January 27, 2023

Version 2

## Product Update: 2016-2020 MDX PGM-FI Idle Stop Software Update

Supersedes 23-001 dated January 6, 2023, to revise the information highlighted in **yellow**.

4. **Connect the i-HDS to the vehicle and select **Start** to begin reprogramming.**

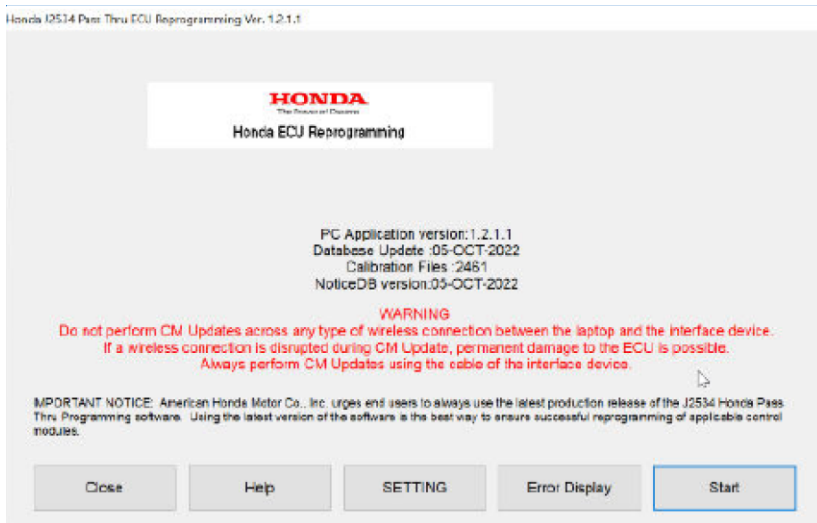
Under SOFTWARE UPDATE PROCEDURE, the Step 4 image was updated and changed parking system to PGM-FI.
